Addendum No. 02

TO: PLANS AND SPECIFICATIONS FOR STATE OF MISSOURI

Construct Six New Cabins
Echo Bluff State Park
Eminence, MO
Project No: X2208-01

1 FLOOR PLAN - POWER - TWO BEDROOM CABIN
SCALE: 1/4" = 1'-0"

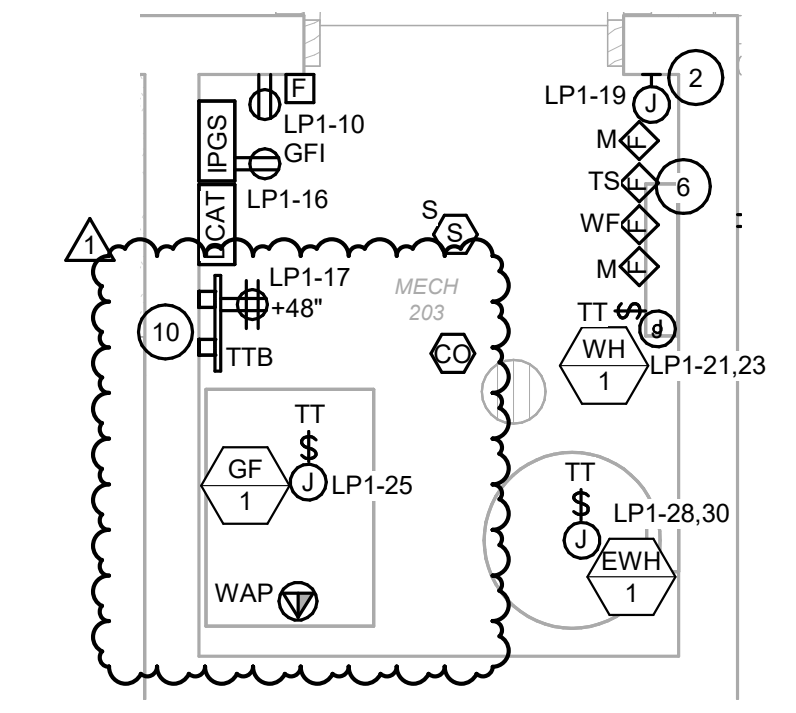
1. Sheet E-103 – See Attached revised sheet E-103

- a. REVISE keynote 10 and associated equipment location as follows:

PROVIDE A TELEPHONE/DATA 8 PORT PATCH PANEL AND TELEPHONE FIBER DEMARC.

1 FLOOR PLAN - POWER - FOUR BEDROOM CABIN
SCALE: 1/4" = 1'-0"

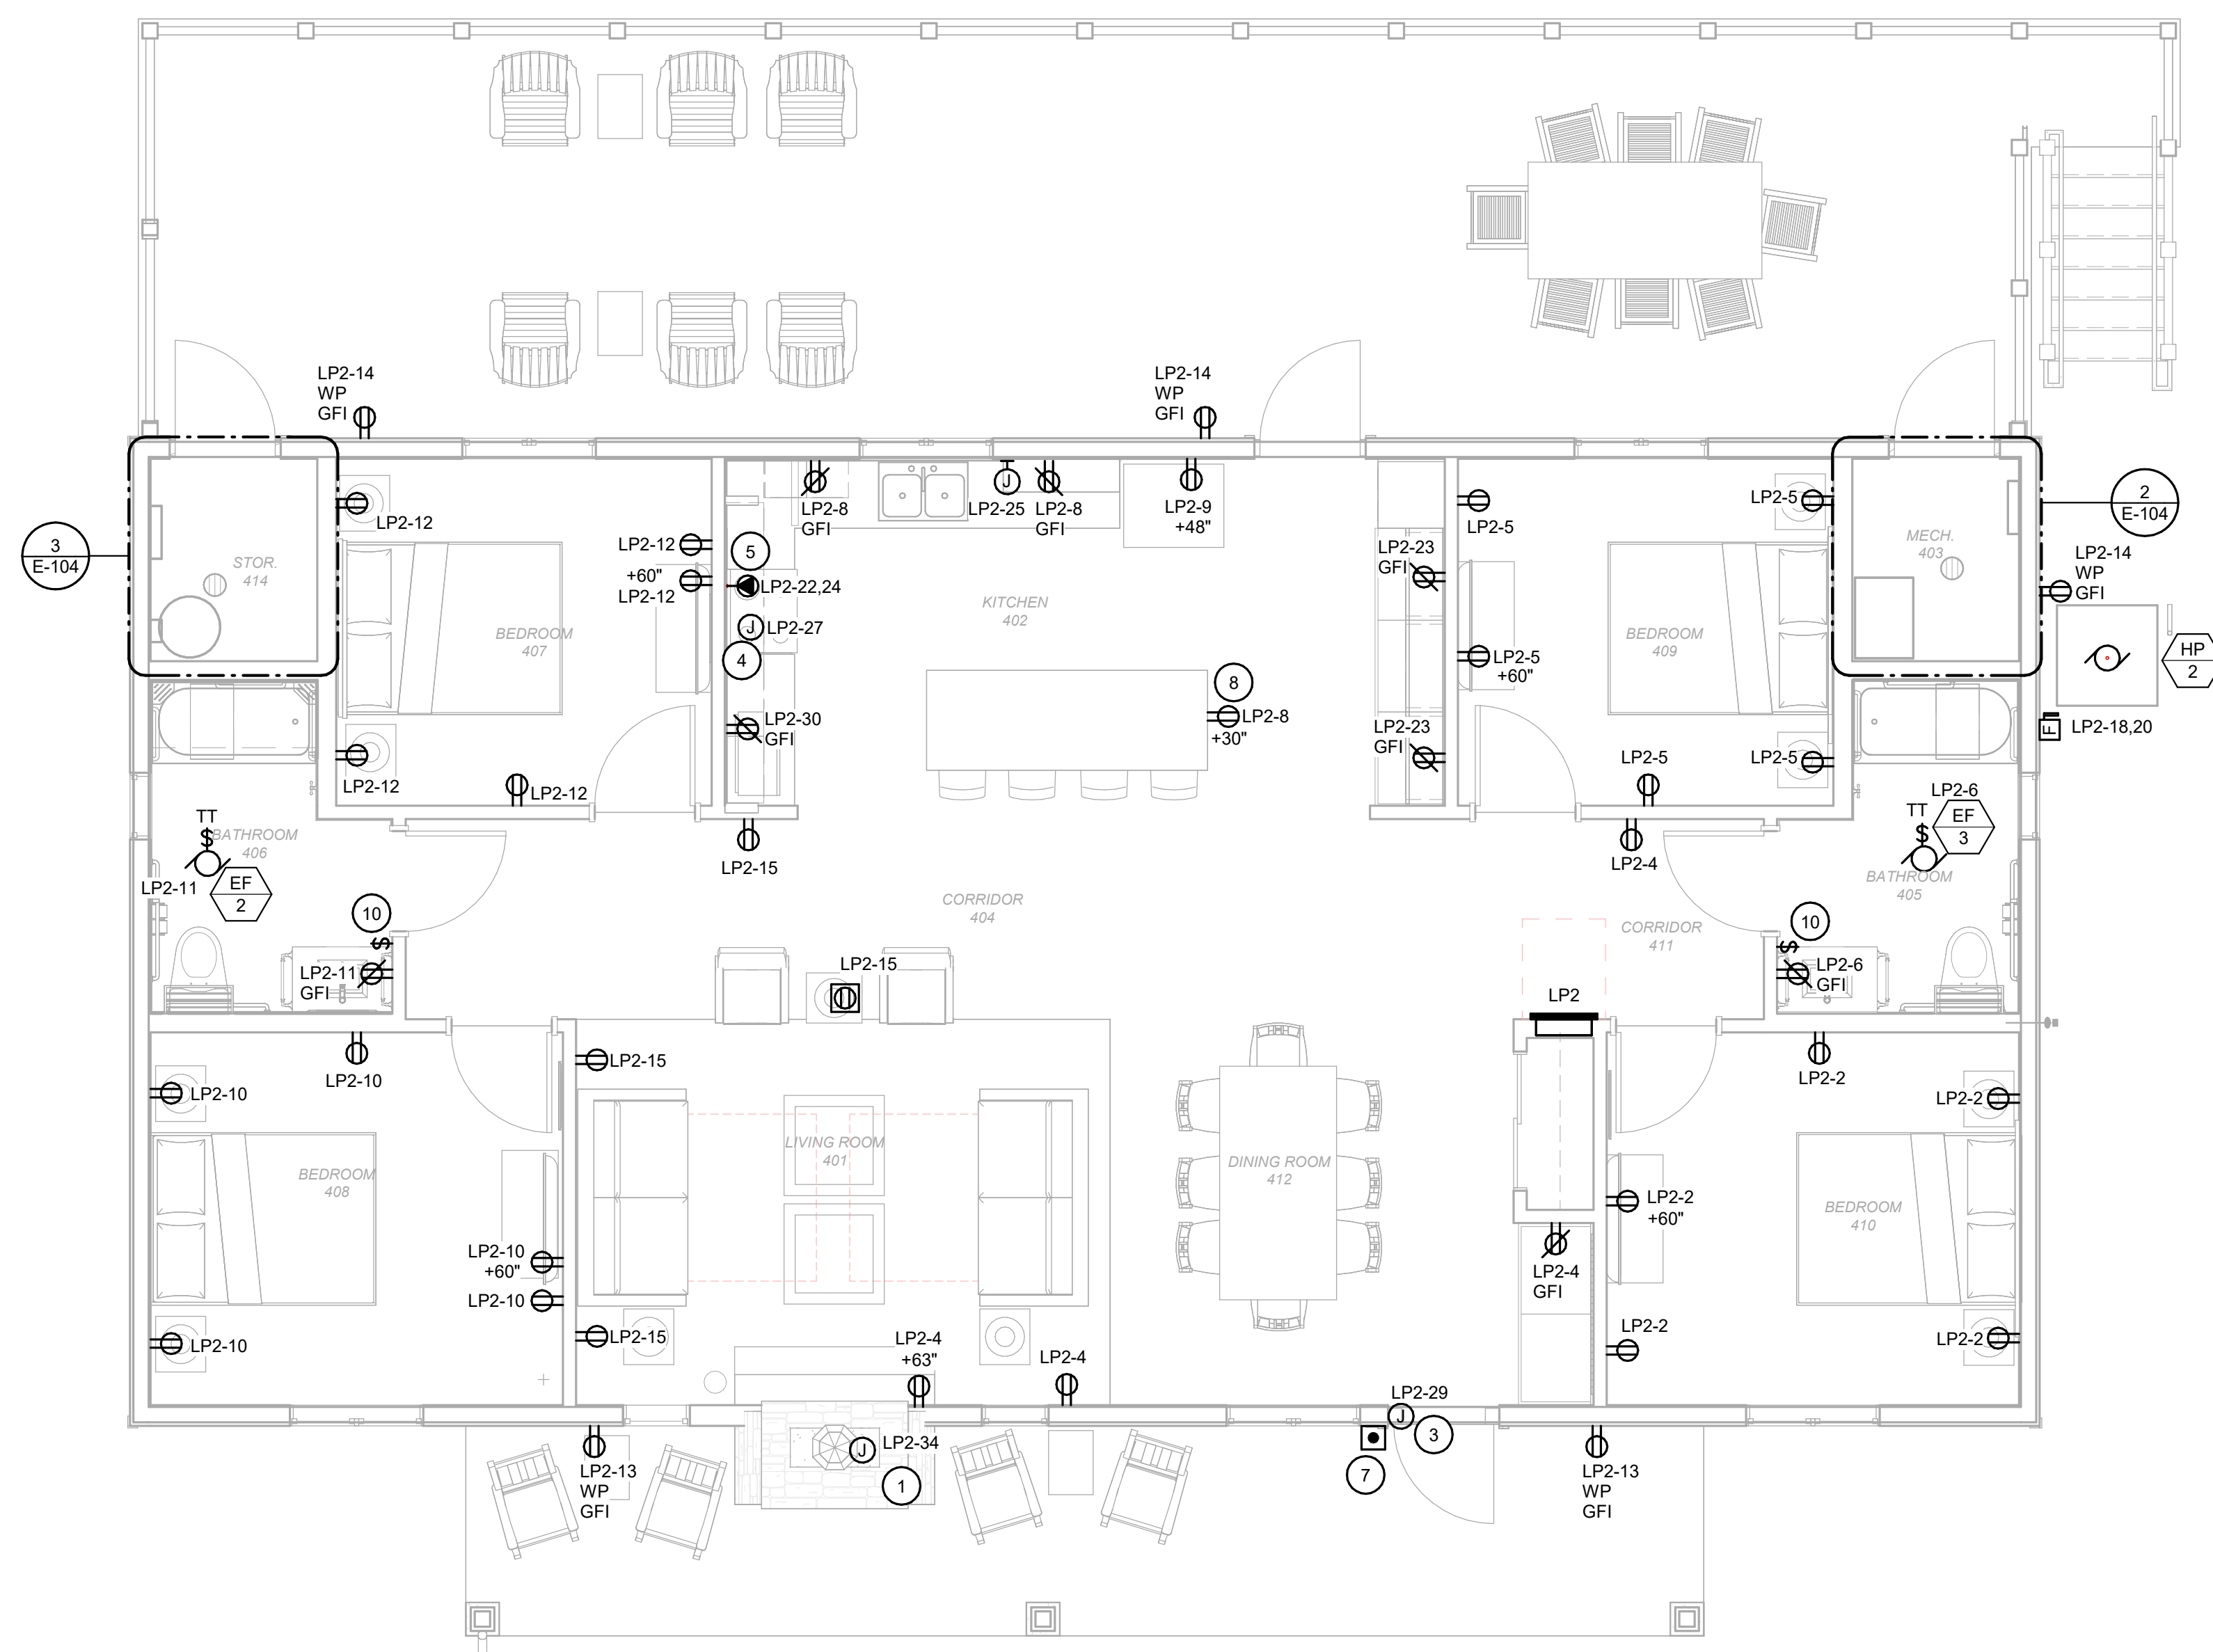
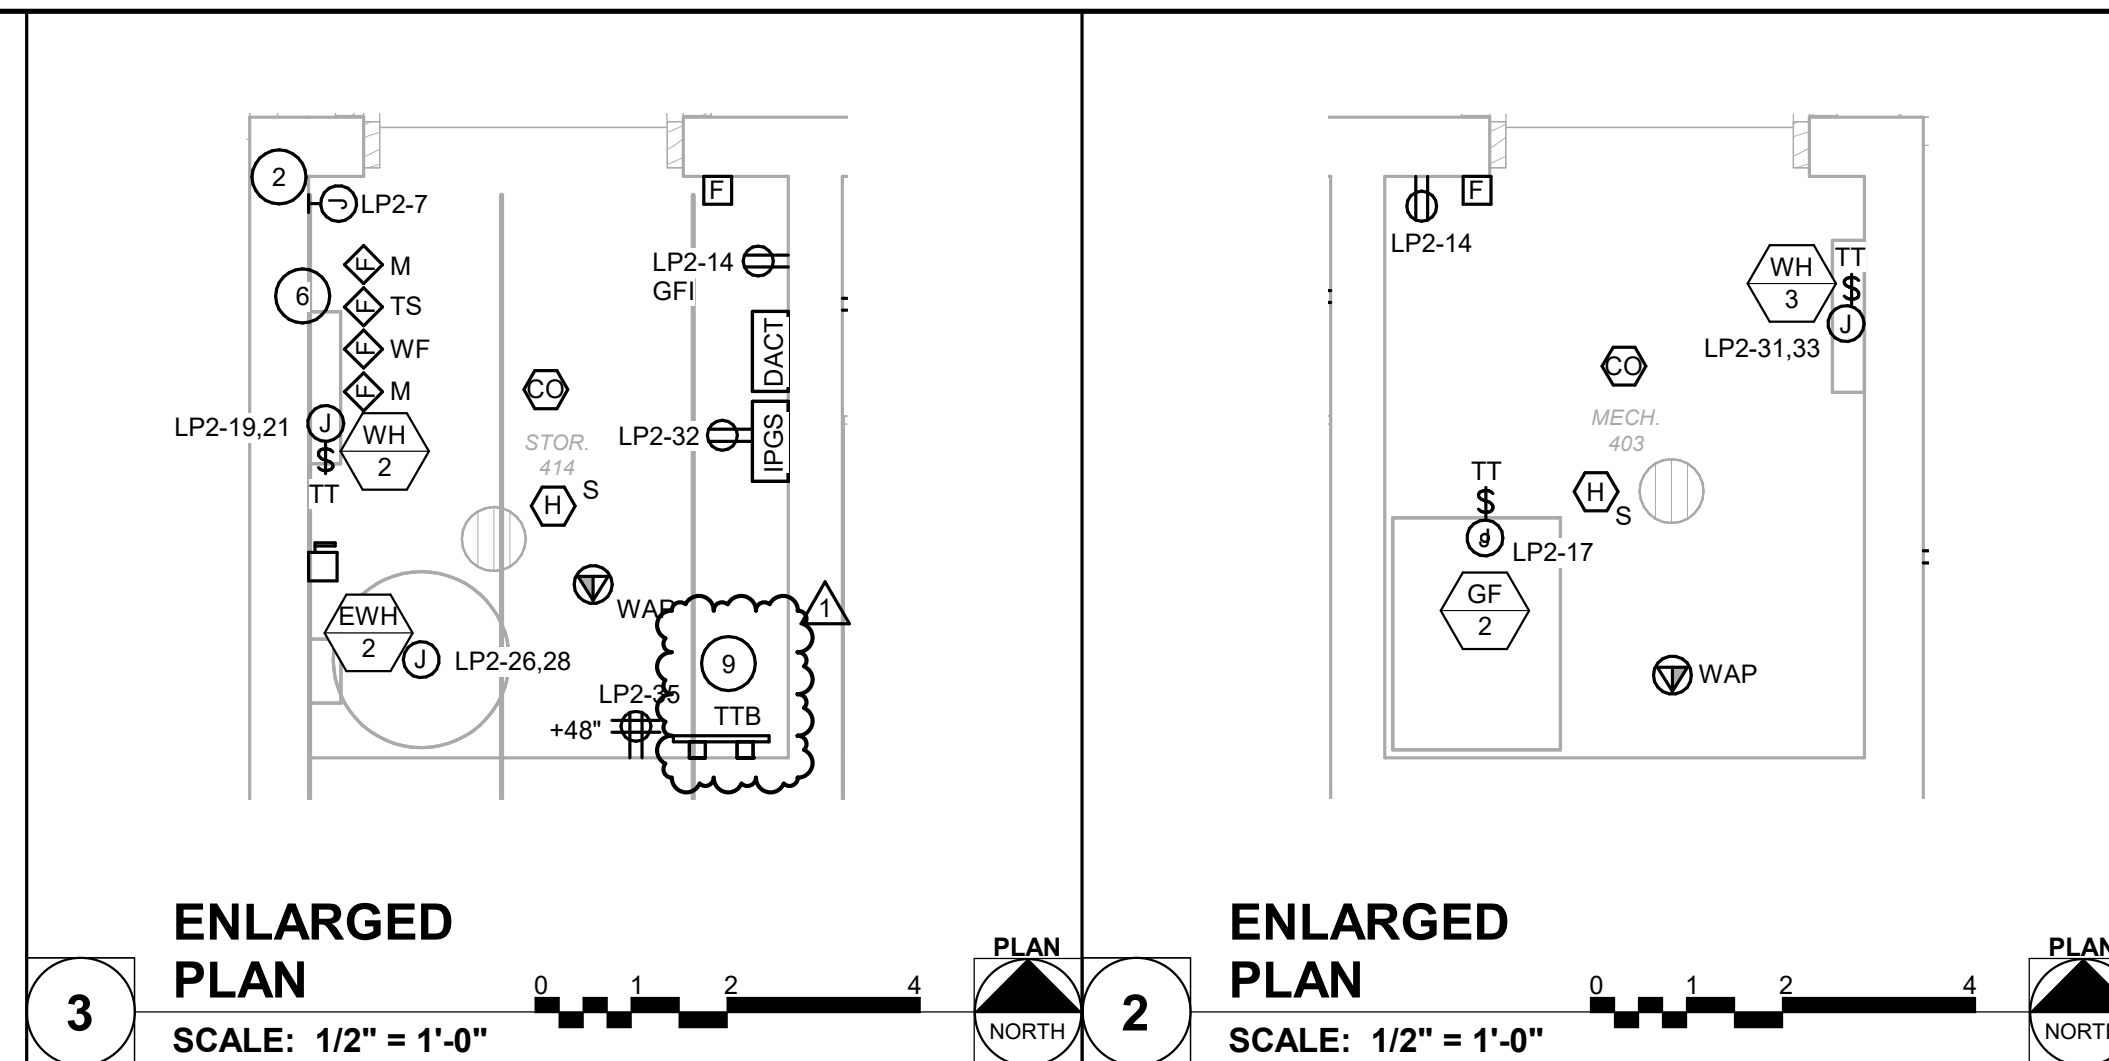
2. Sheet E-104 – See Attached revised sheet E-104

- a. REVISE keynote 9 and associated equipment location as follows:

PROVIDE A TELEPHONE/DATA 8 PORT PATCH PANEL AND TELEPHONE FIBER DEMARC.

1 ELECTRICAL SITE PLAN
SCALE: 1" = 20'-0"

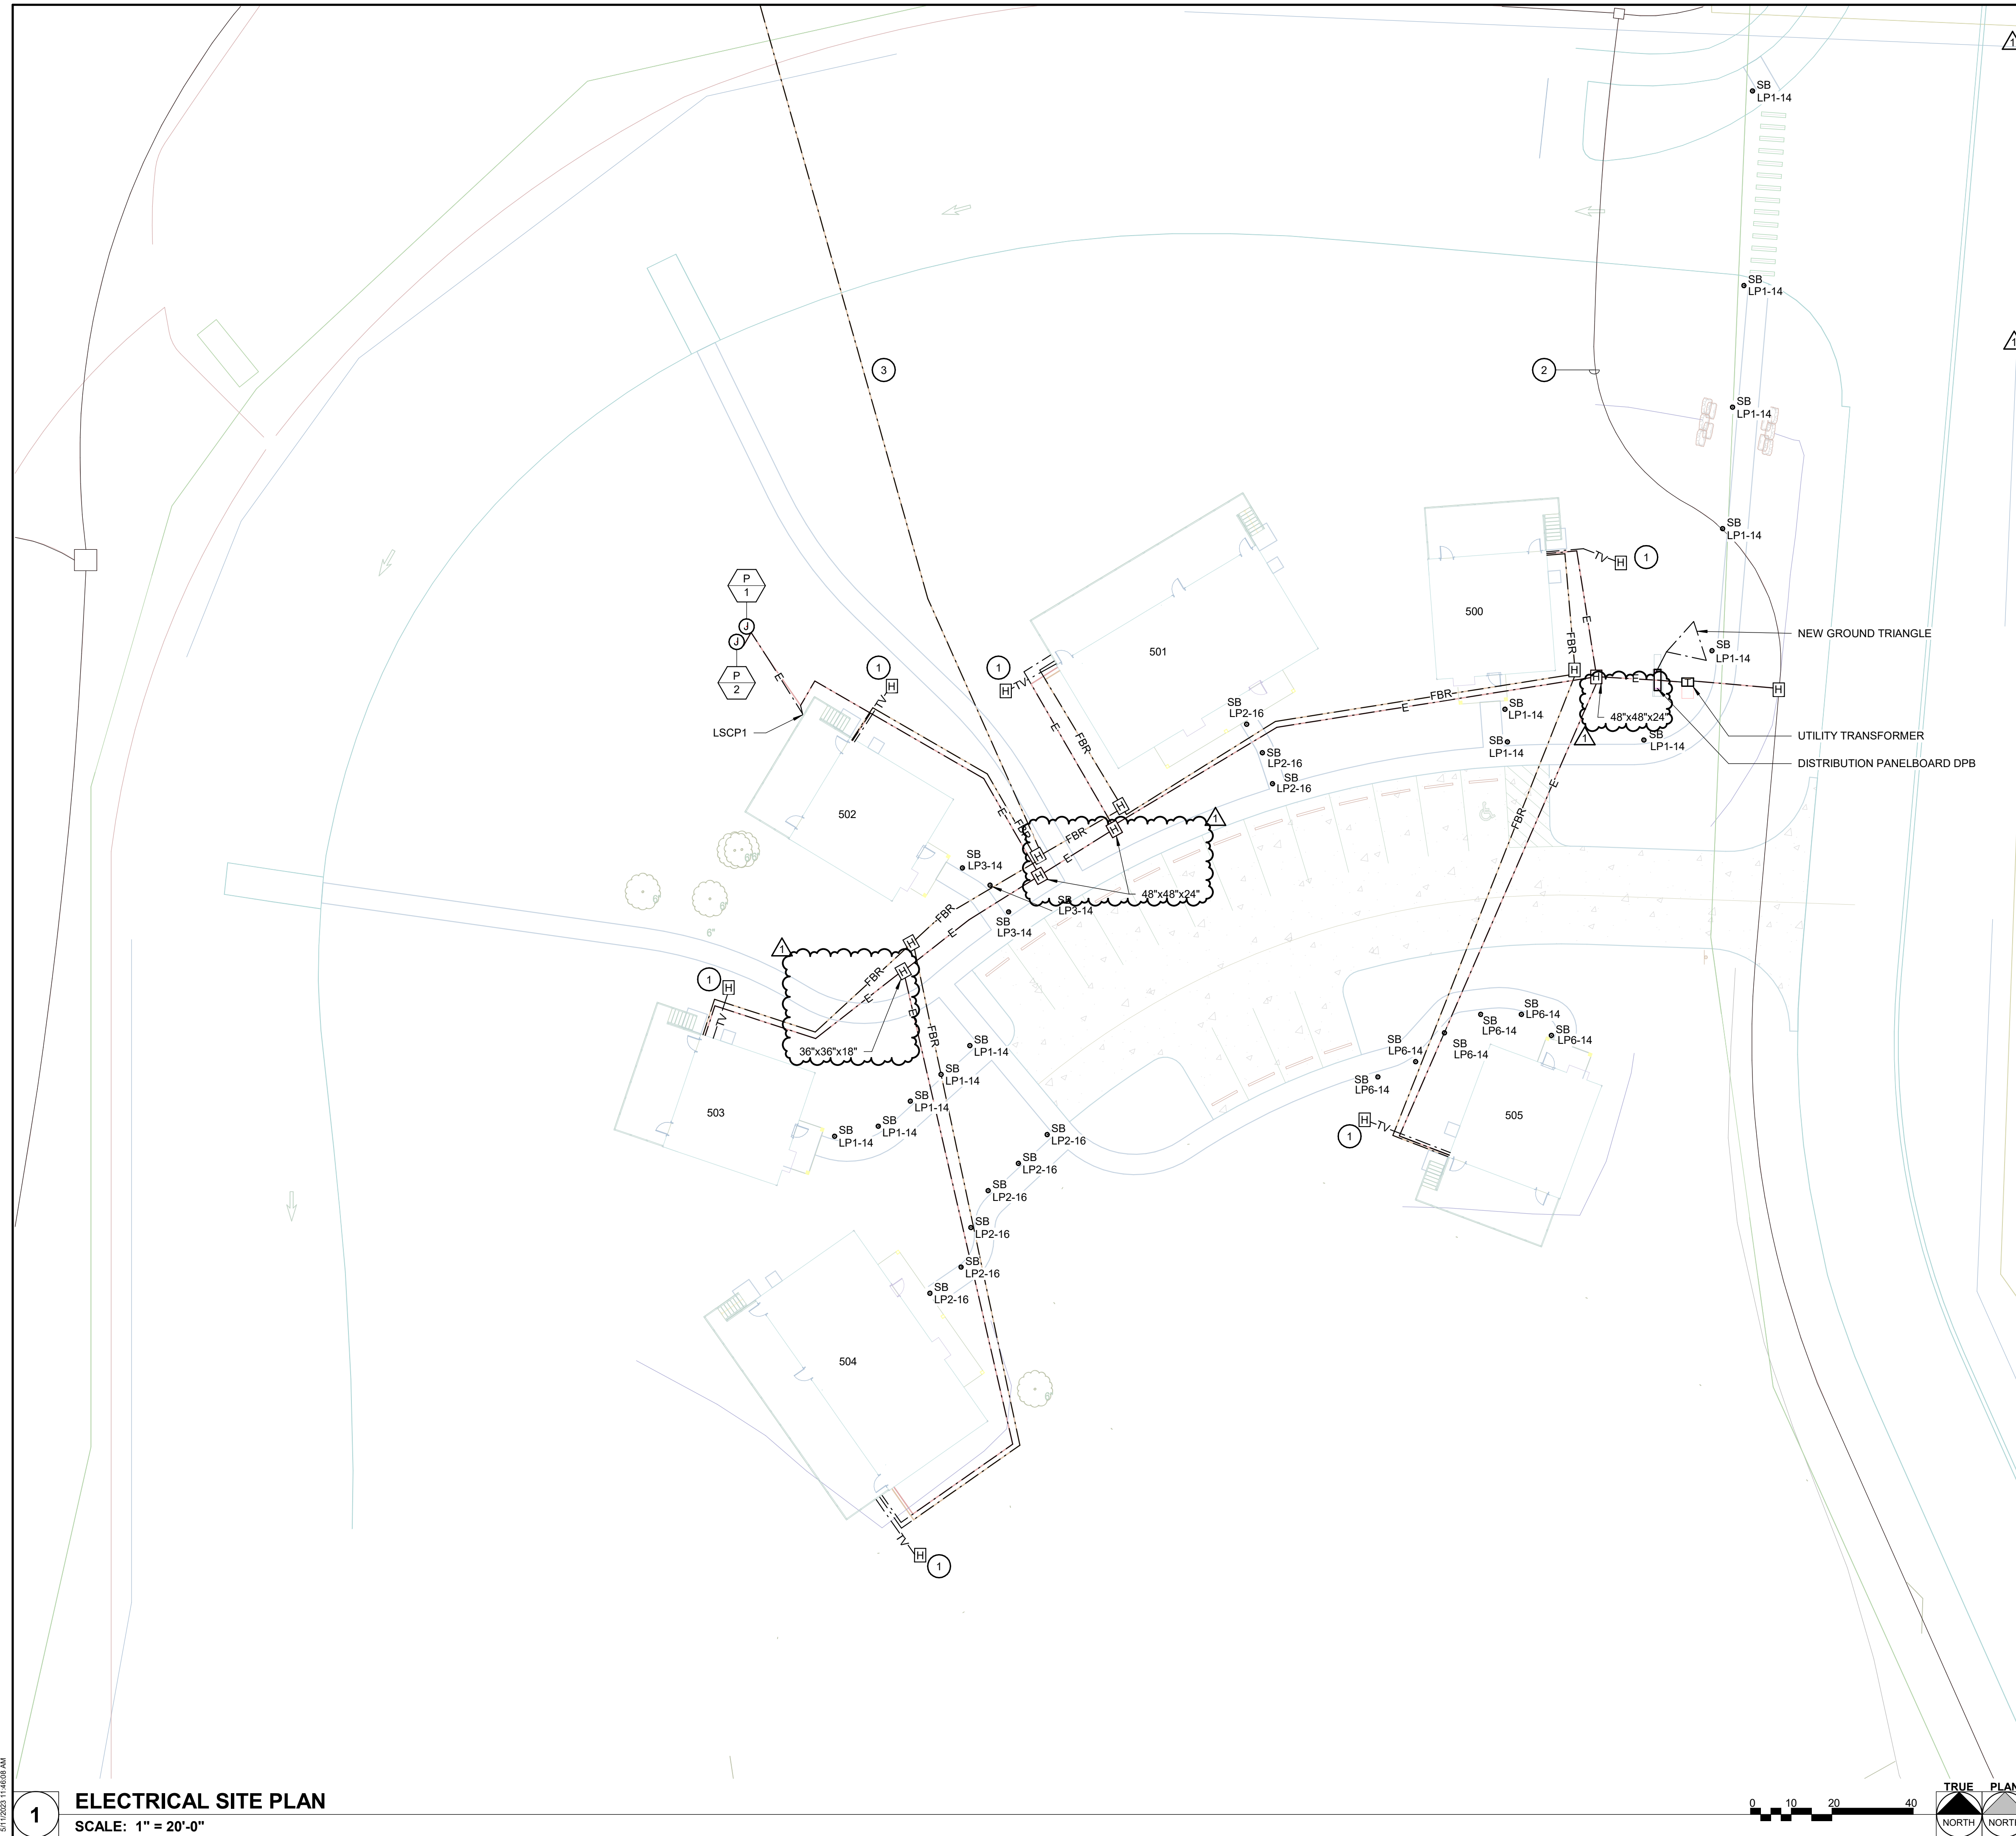
3. Sheet E-401 – See Attached revised sheet E-401

- a. REVISE general note A as follows:

b. ADD general note B as follows:

c. ADD general note C as follows:

d. REVISE keynote 3 as follows:

e. REVISE Electrical Site Plan to add handhole sizes.

UTILITY COMPANY: HOWELL OREGON COOPERATIVE 417-256-2131

TELEPHONE COMPANY: CENTURYLINK 417-255-8221

B. PROVIDE PULL BOXES FLUSH WITH EVERY 300' ALONG TELEPHONE FIBER CONDUIT. PROVIDE A PEDESTAL EVERY 900' ALONG TELEPHONE FIBER. THE PEDESTAL SHALL AS A PULL BOX. PROVIDE ADDITIONAL PEDESTALS AS NECESSARY TO ACCOMMODATE CABLE LENGTHS. SPLICING OF FIBER OPTIC CABLES WILL NOT BE ACCEPTABLE.

C. ALL PEDESTAL & DEMARCATION LOCATIONS MUST ACCOMODATE FIBER TERMINATIONS TO BE MOUNTED. LOCKED AND MAINTAINED BY STATE OF MISSOURI (SOM) STAFF.

PROVIDE (6) 2-STRAND MULTI-MODE FIBER OPTIC CABLES, RATED FOR OUTDOOR WET LOCATIONS IN 4" C FROM EXISTING MAIN FIBER CONNECTION IN LODGE. FIBER OPTIC CABLE TO TERMINATE ON FIBER DEMARC IN MECHANICAL ROOM FOR EACH CABIN.
